## **14.1.9 Loss of External Electrical Load**

### **Accident Description**

FIGURE 14.2.6-6

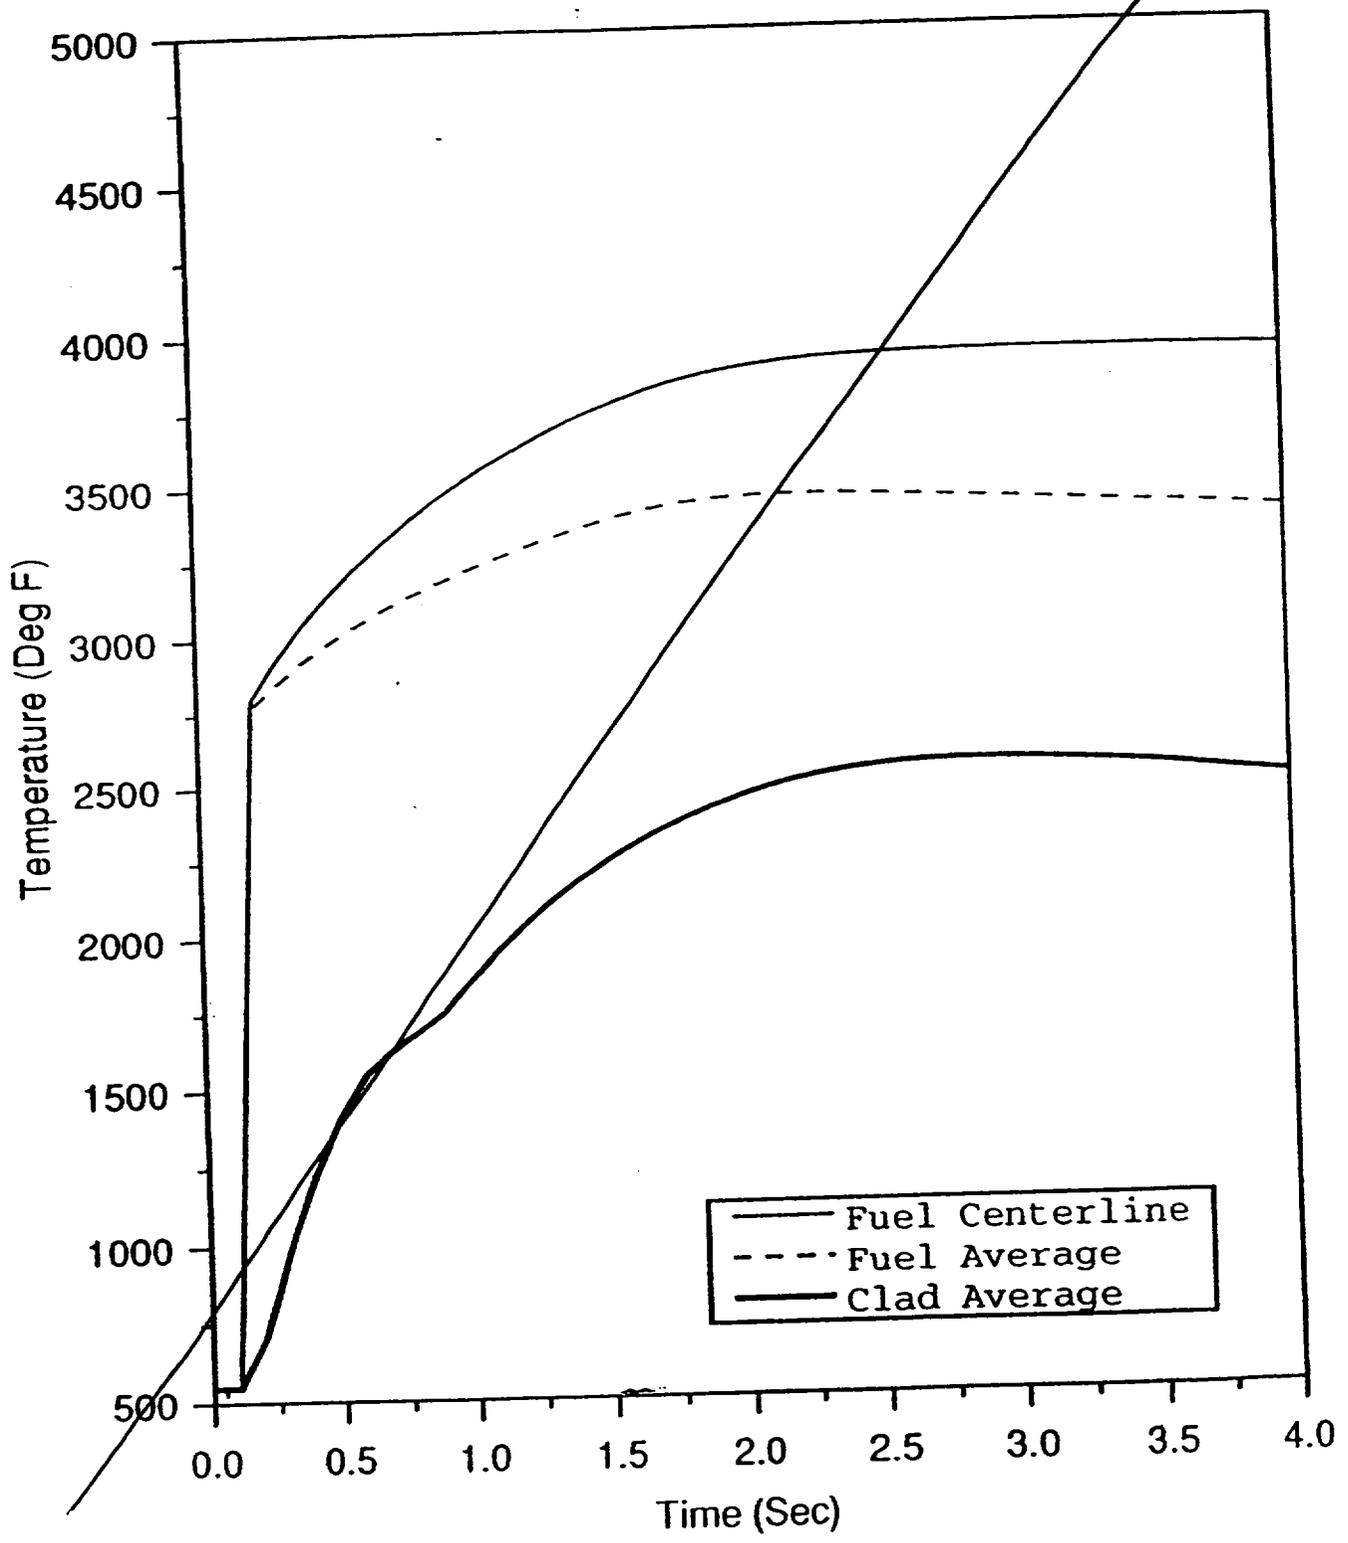
replace

Figure 14.2.6-7

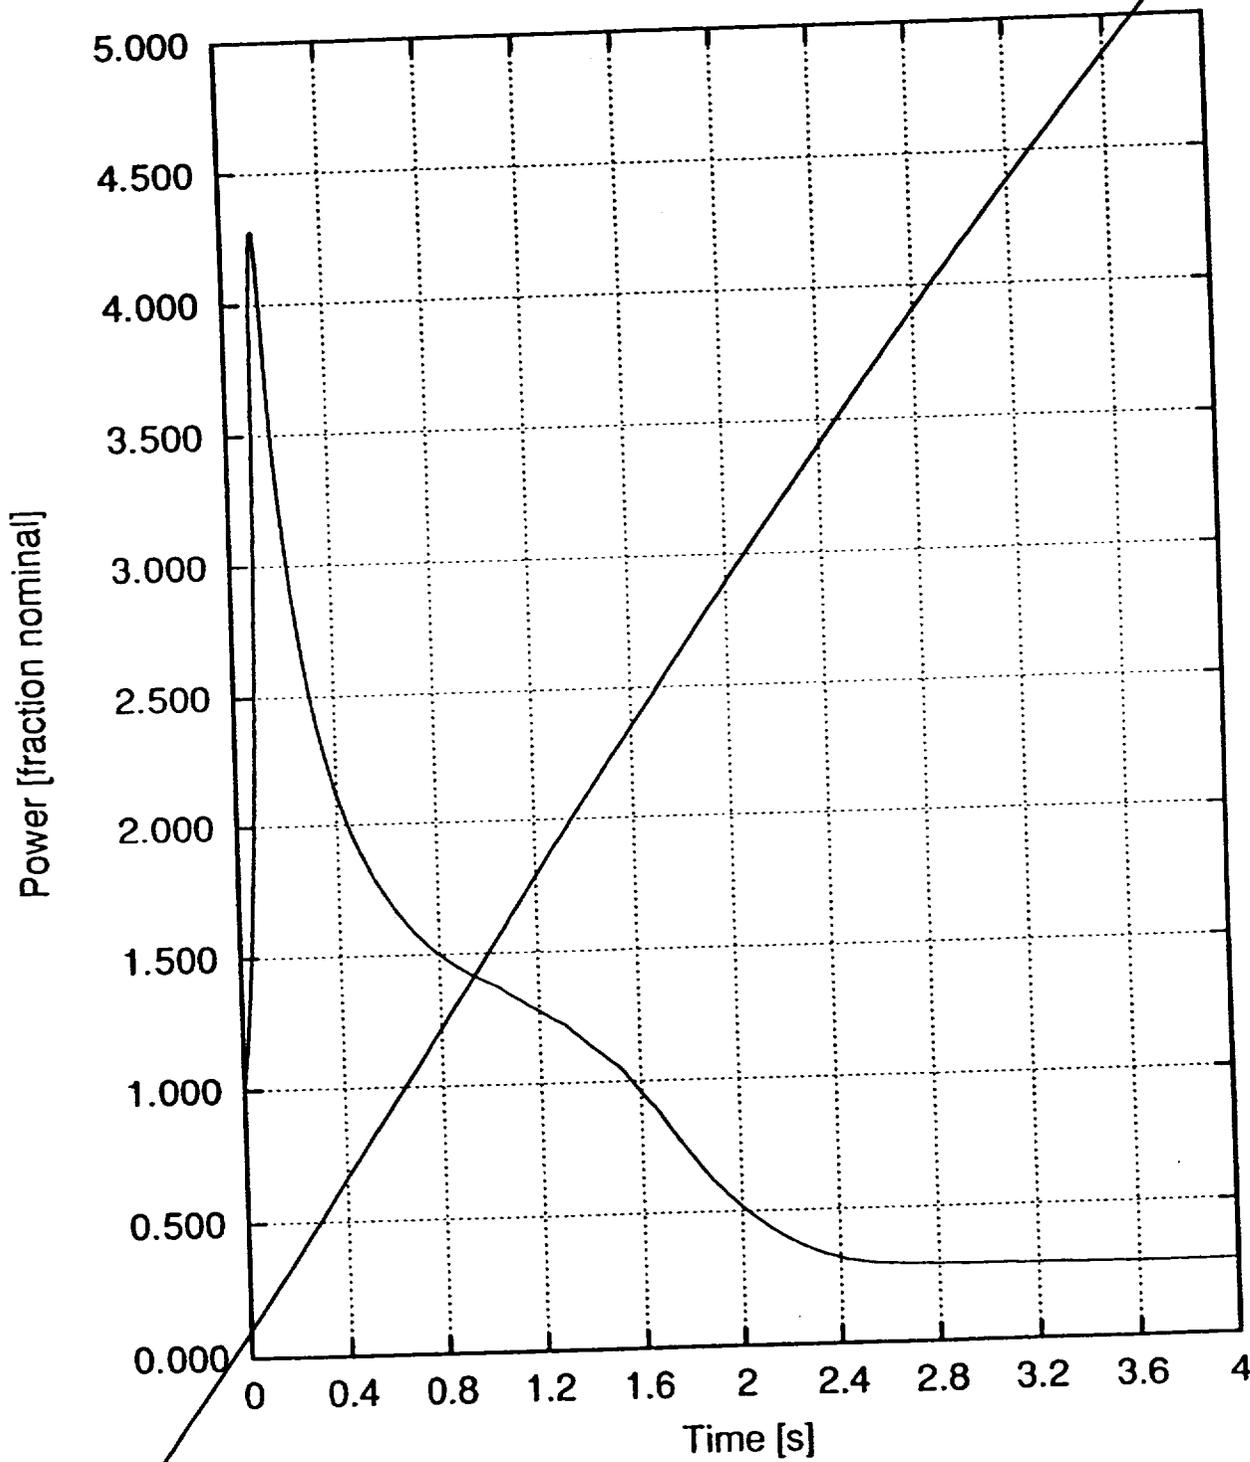
replace

Figure 14.2.6-8

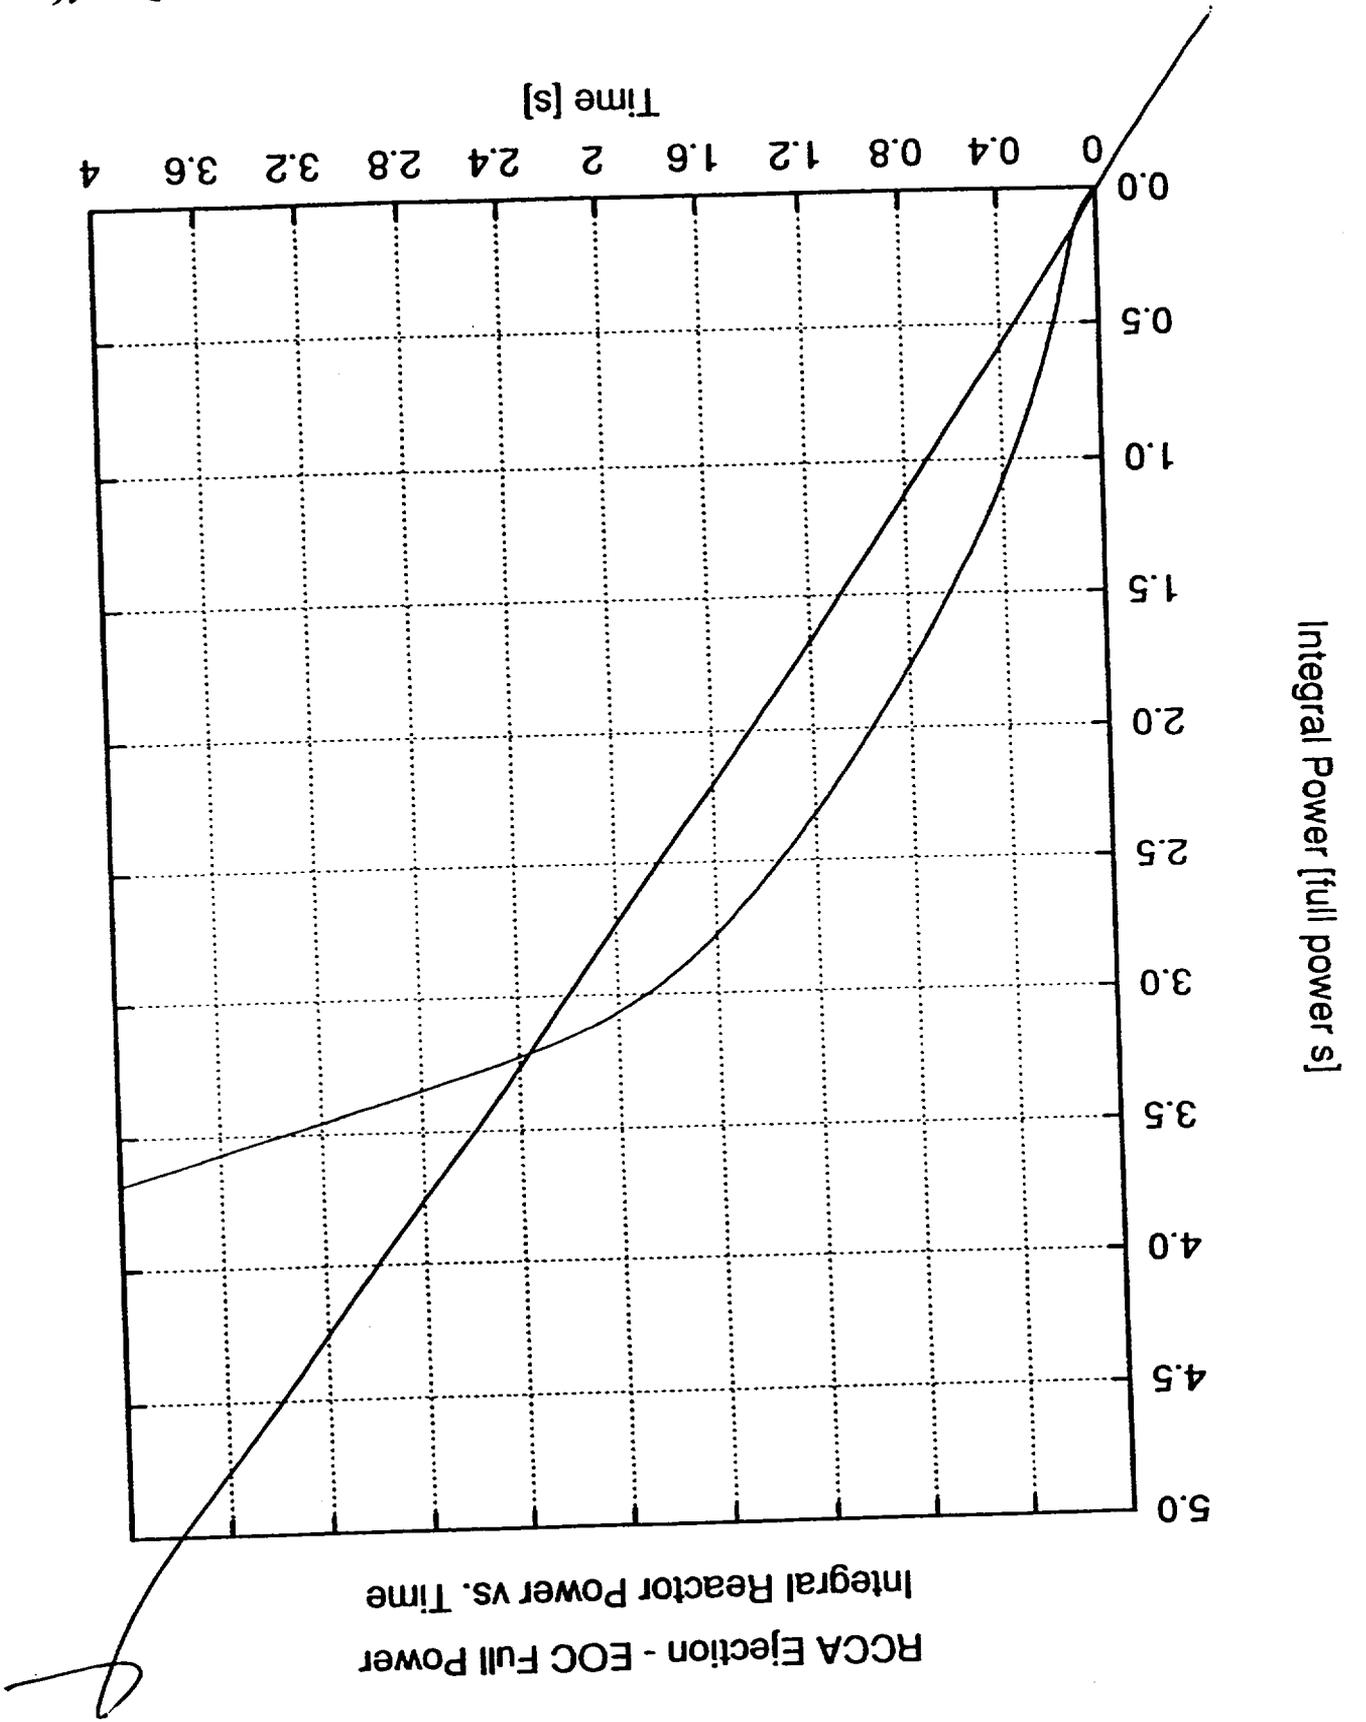
*delete*

Figure 14.2.6-9

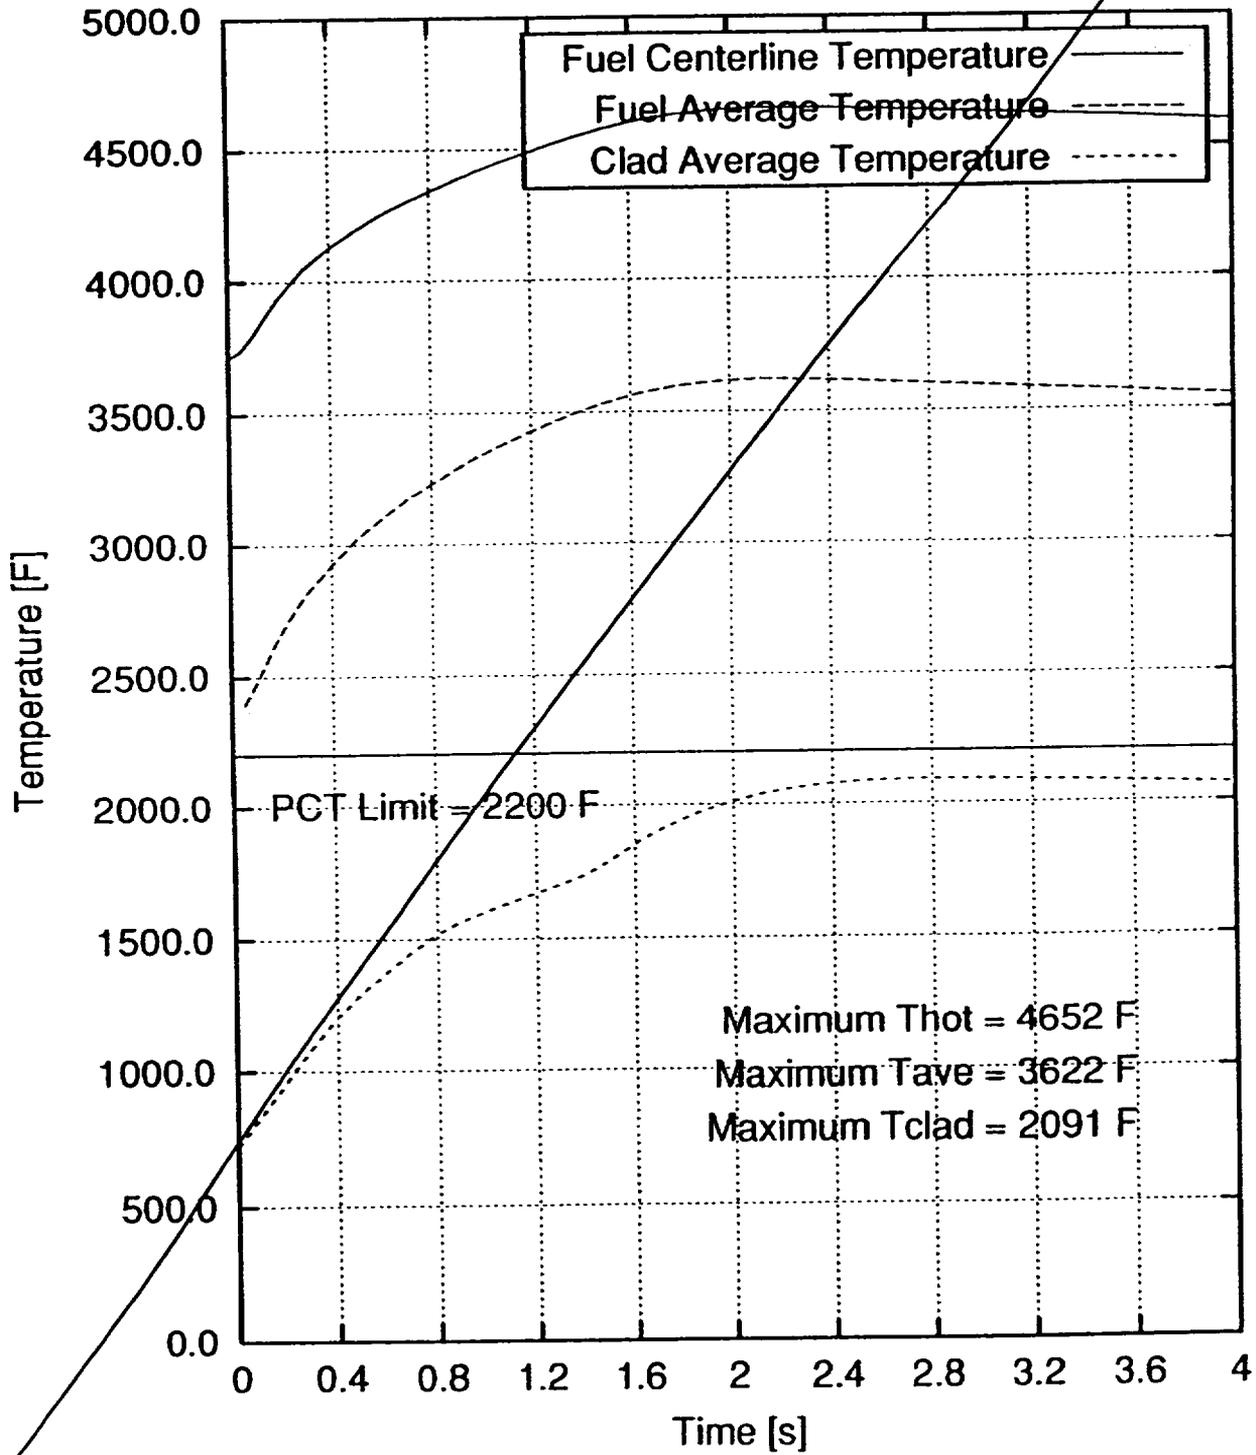
replace

FIGURE 14.2.6-10

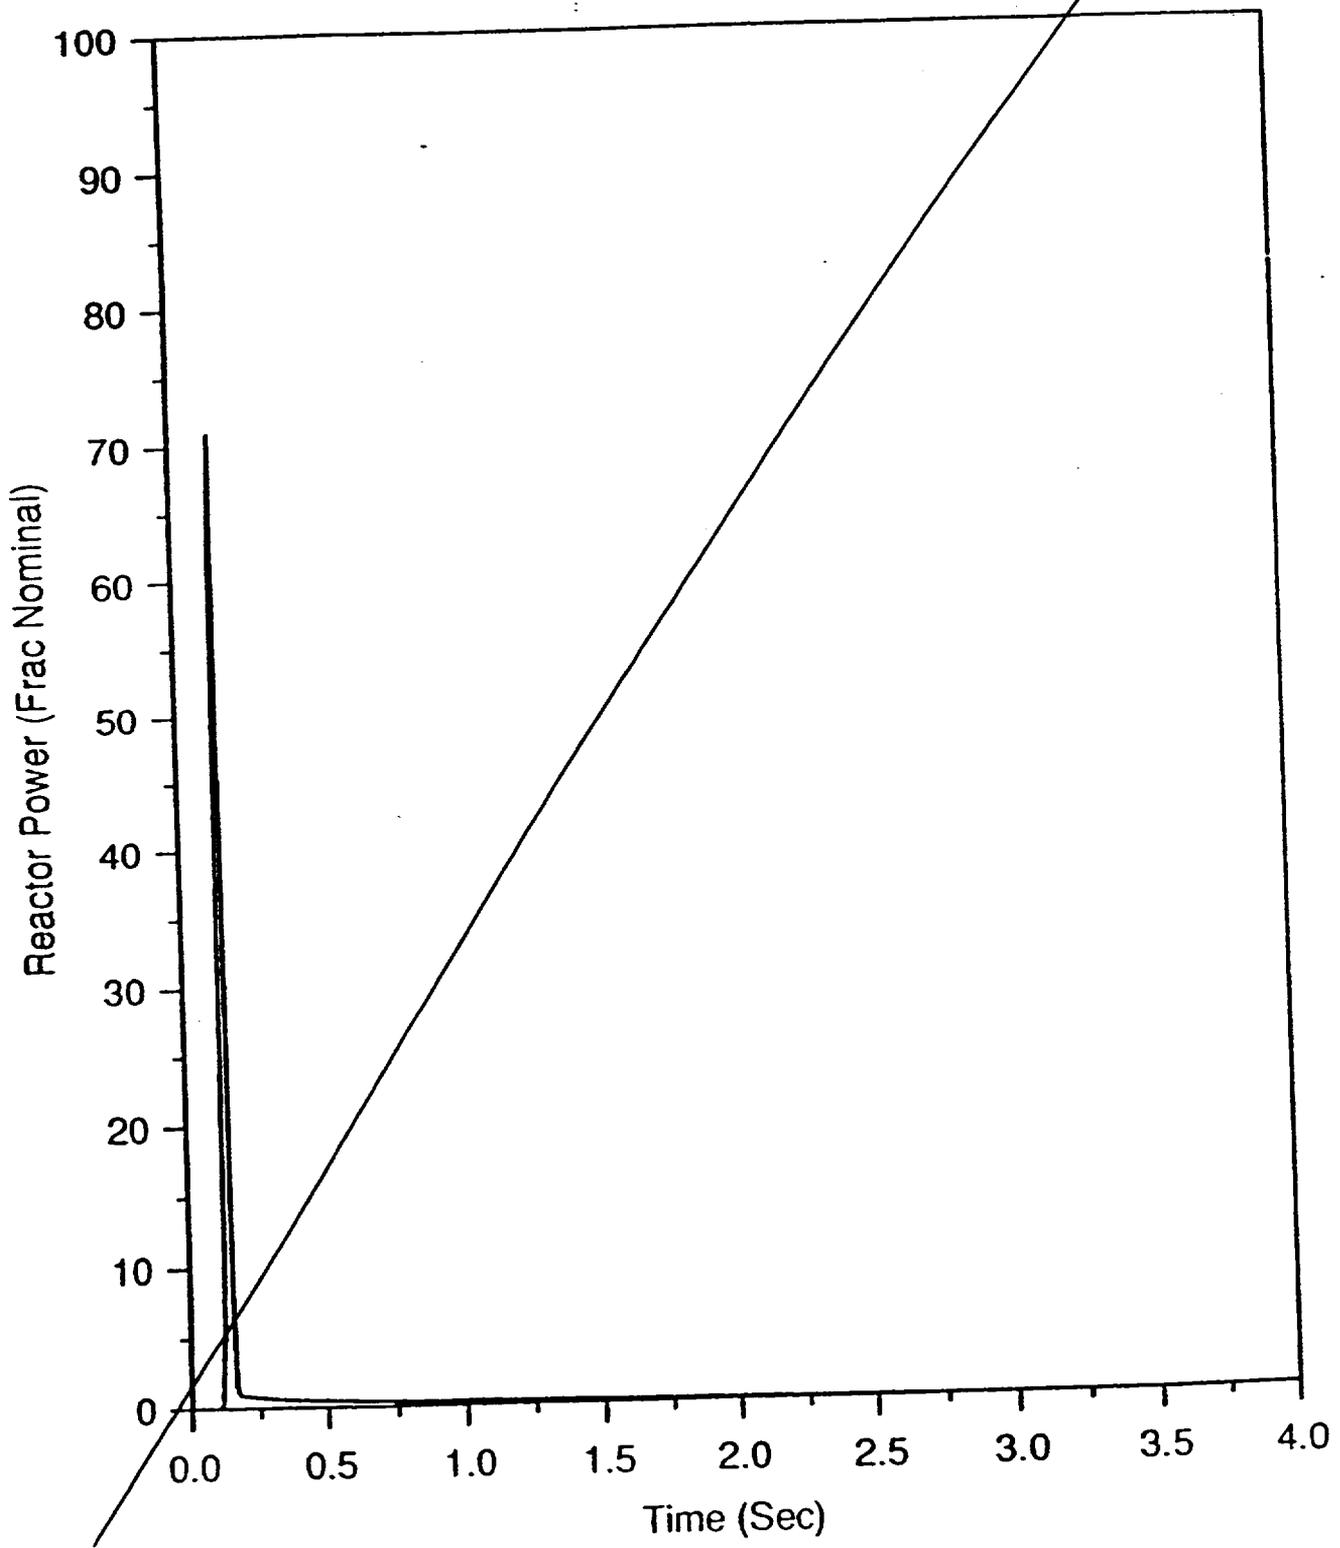
replace
